**ADDENDUM
NO. 2**

**CROWN POINT COMMUNITY SCHOOL CORPORATION -
ATHLETIC TURF IMPROVEMENTS
Crown Point, IN 46307**

ADDENDUM TWO

Addendum Two (AD.02) to the drawings and specifications prepared by Gibraltar Design and The Skillman Corporation for **Crown Point Community School Corporation – Athletic Turf Improvements** for Crown Point Community School Corporation, Crown Point, Indiana.

TYPICAL BACKSTOP FENCE POST DETAIL
SCALE: 1 1/2" = 1'-0"

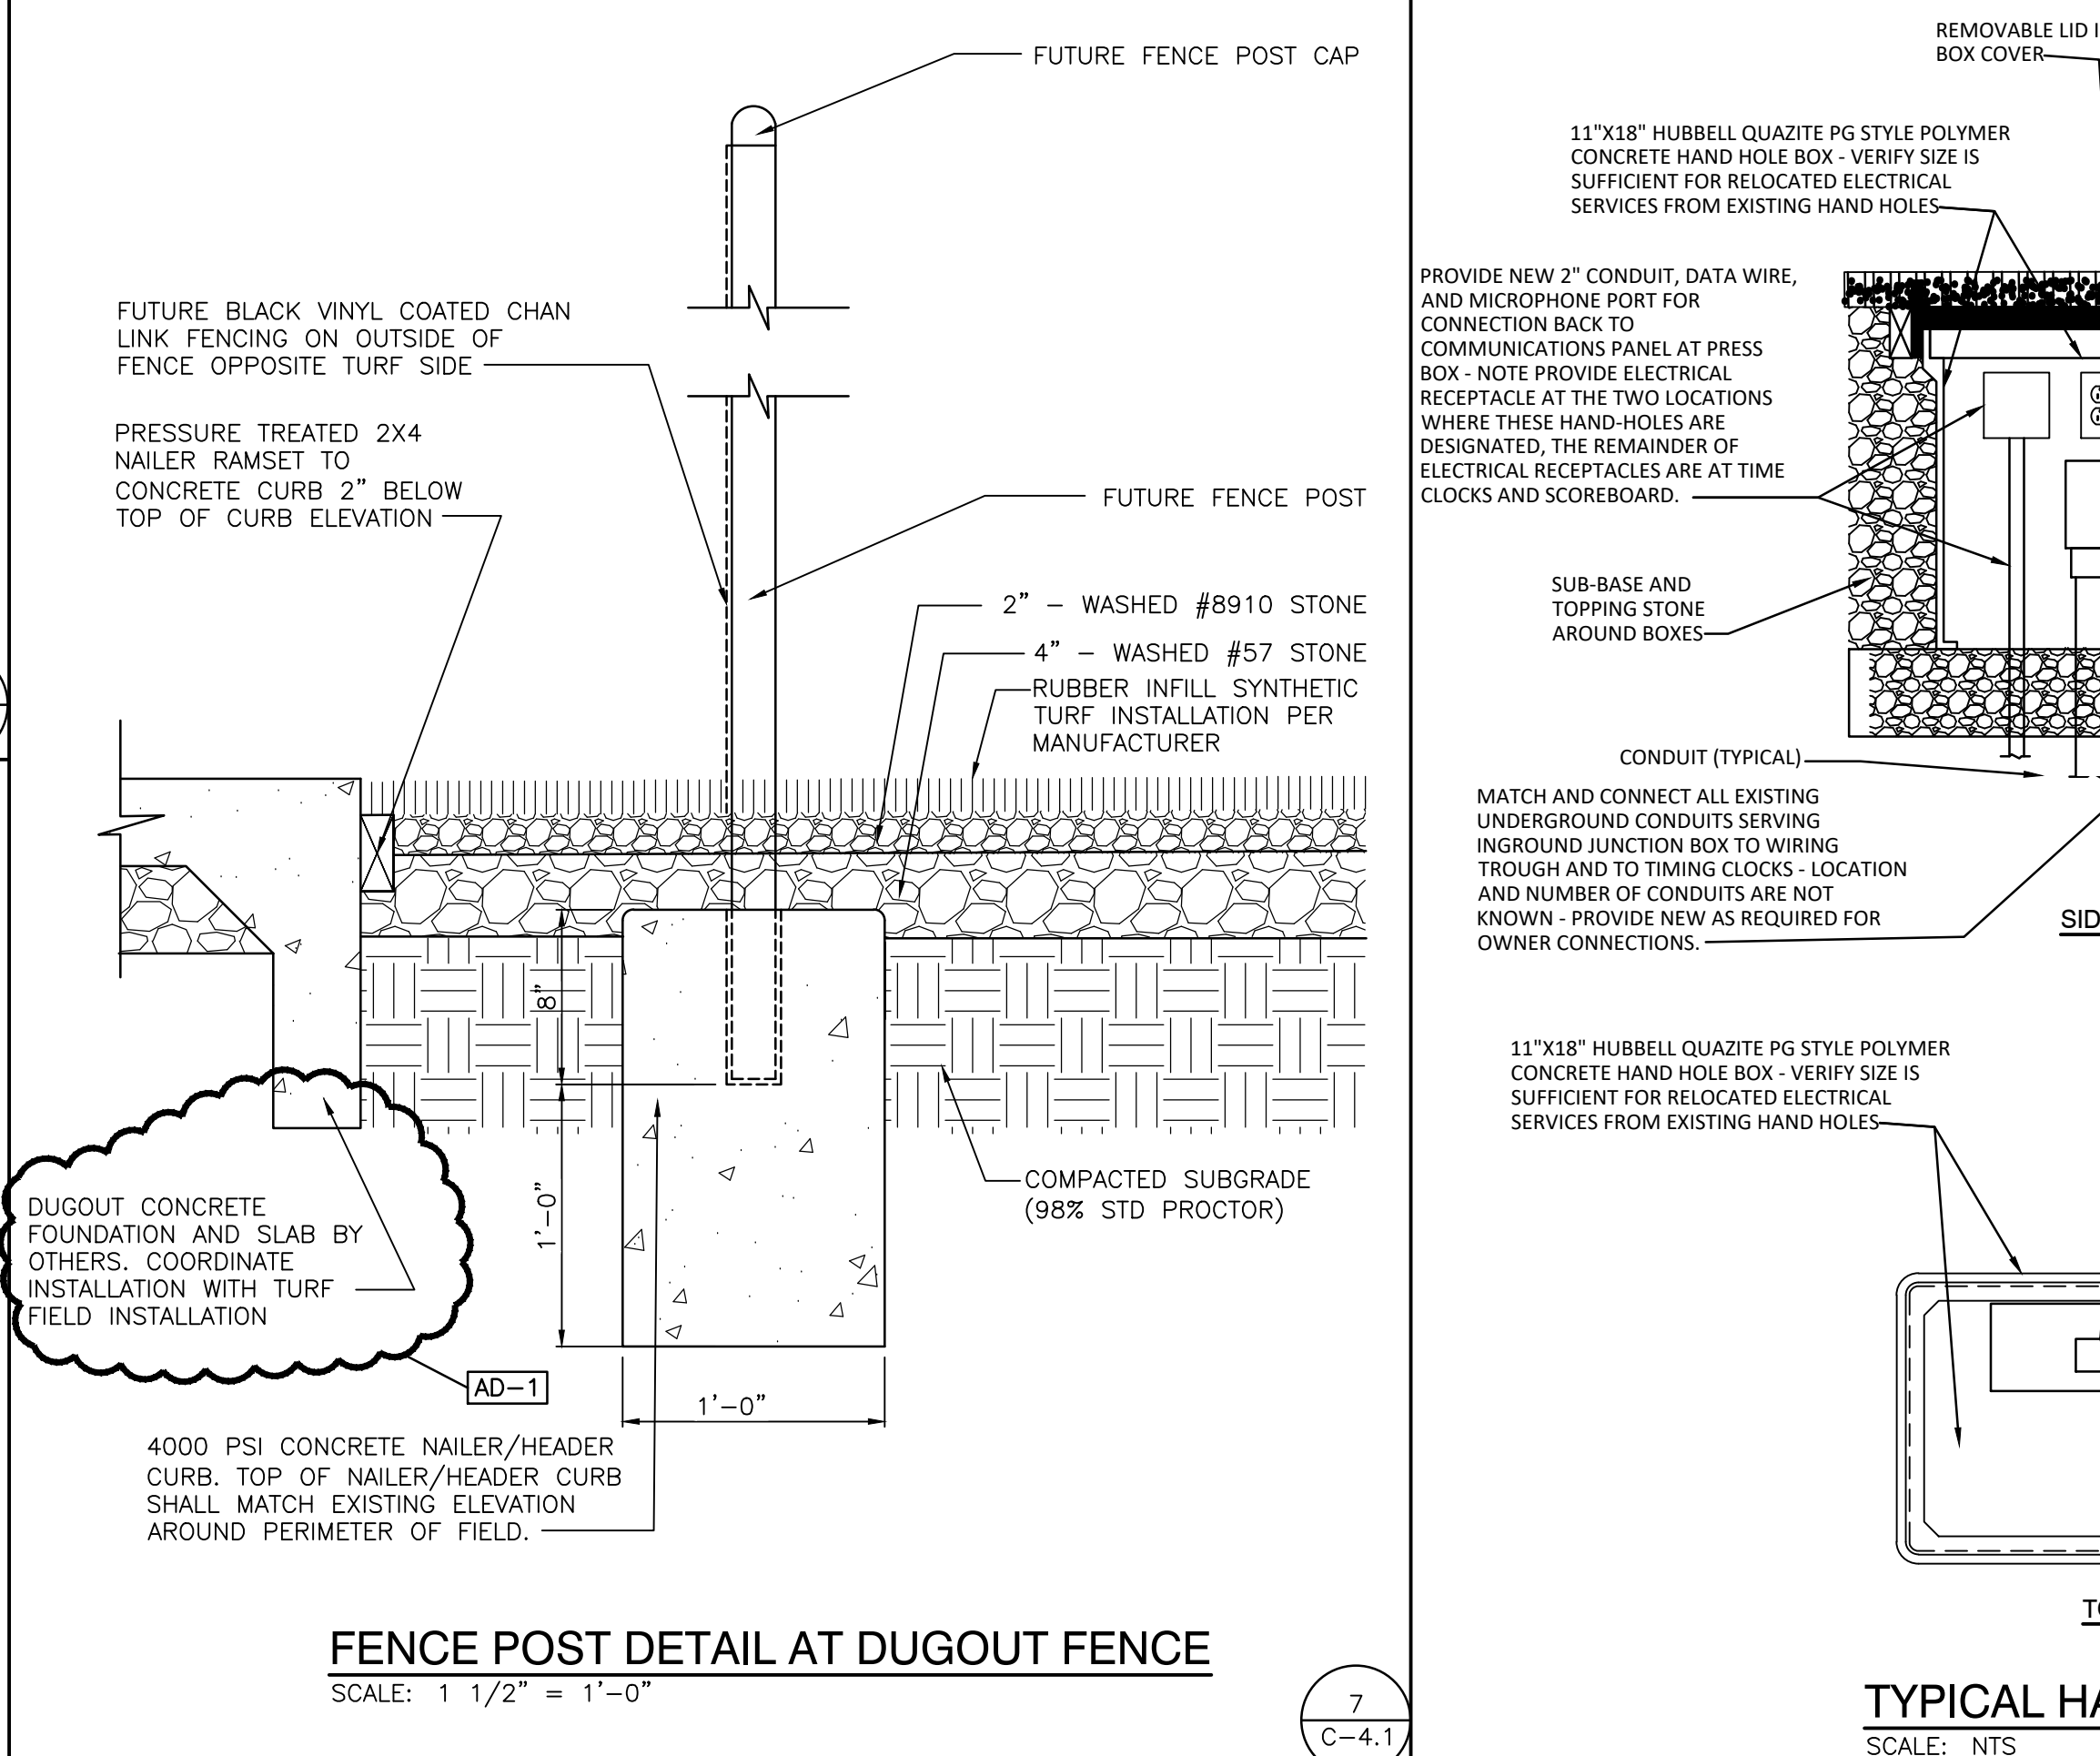
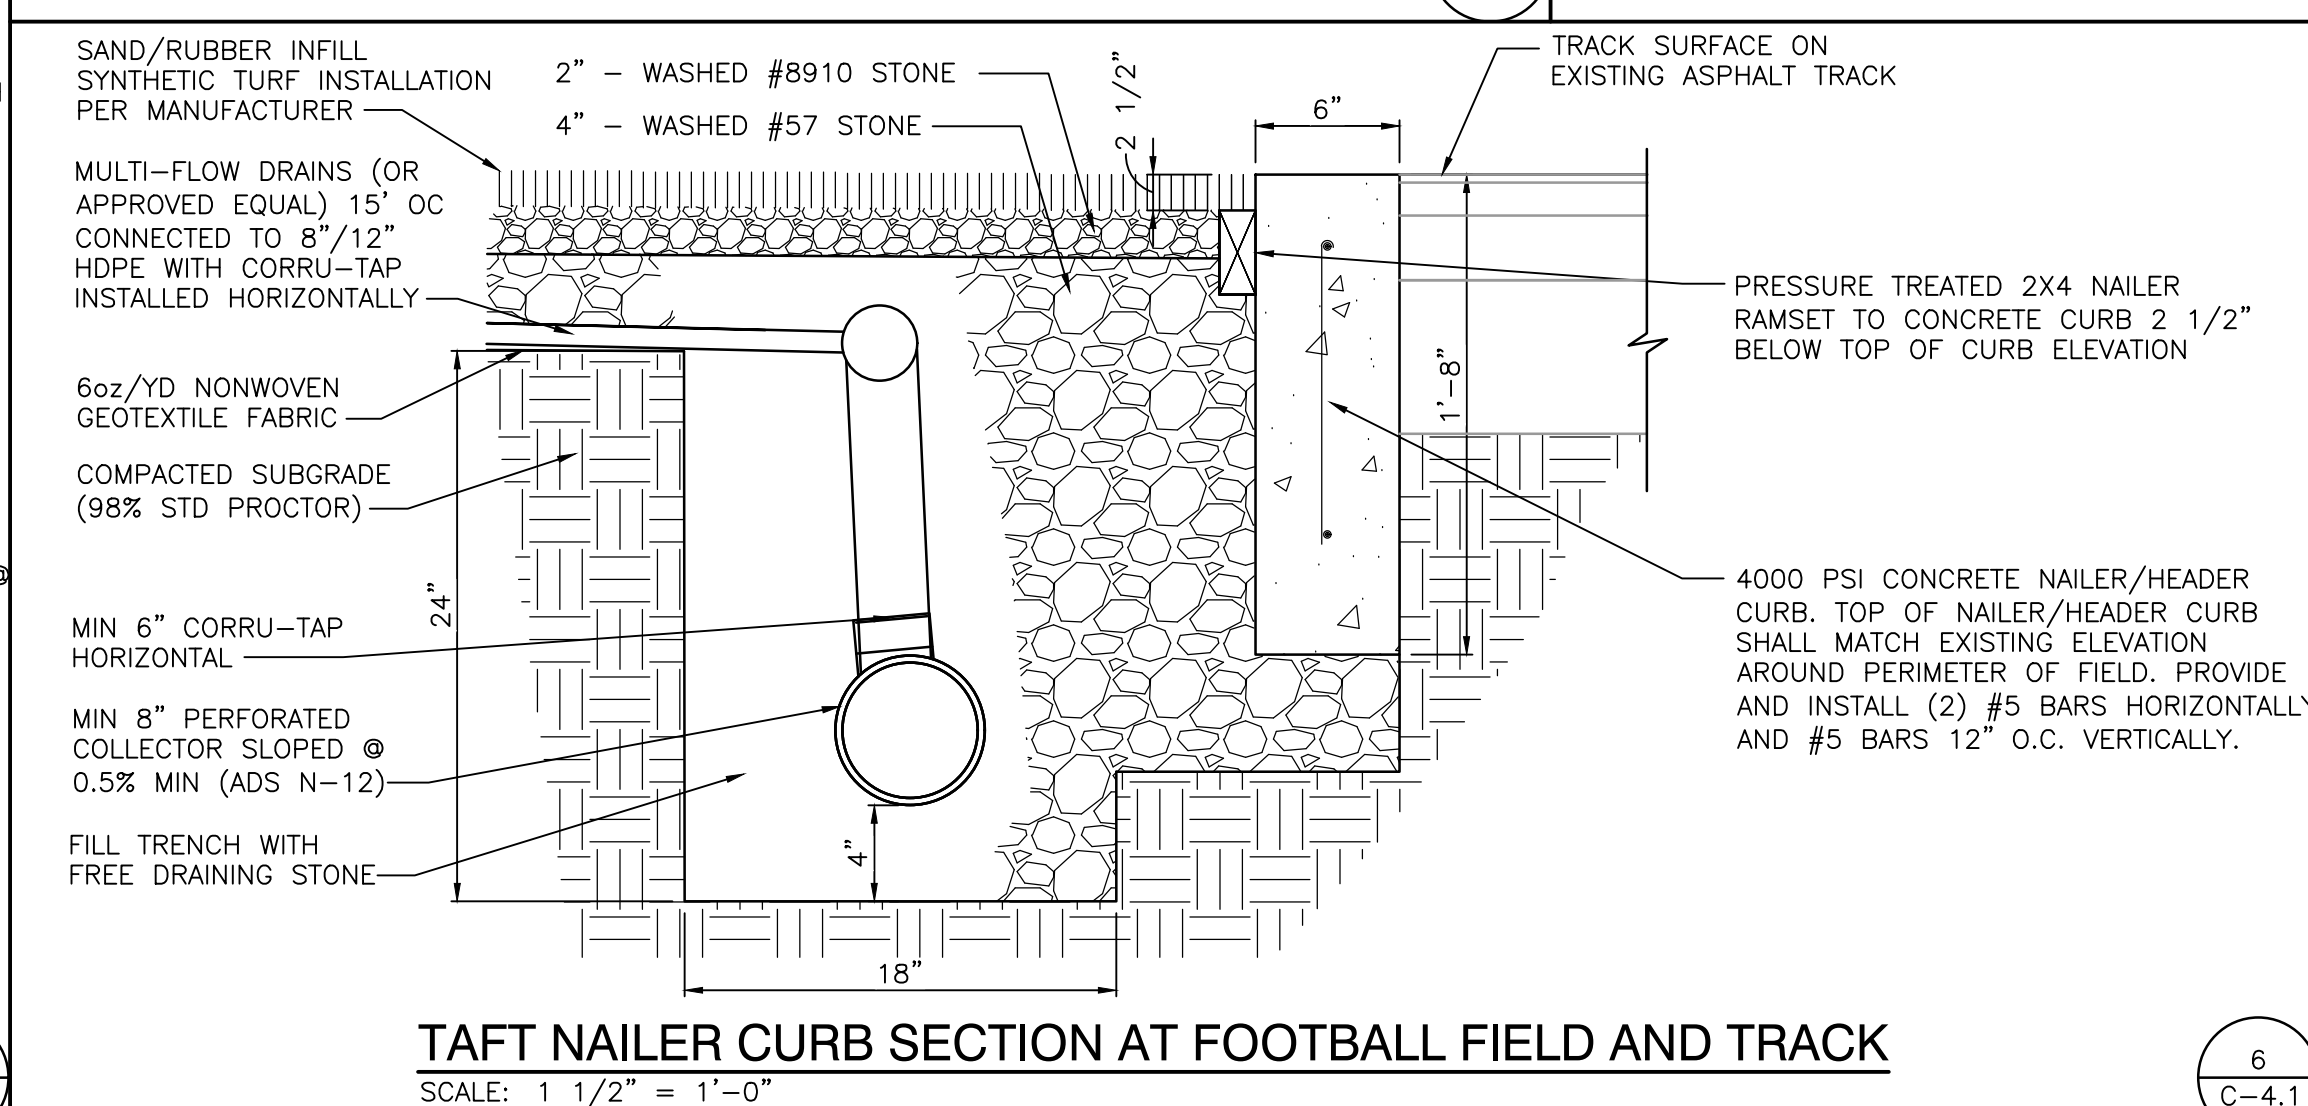
7. Sheet C-4.1

- A. Refer to revised, full-size drawing, included in this Addendum, for revisions to detail 5/C-4.1 and 8/C-4.1.
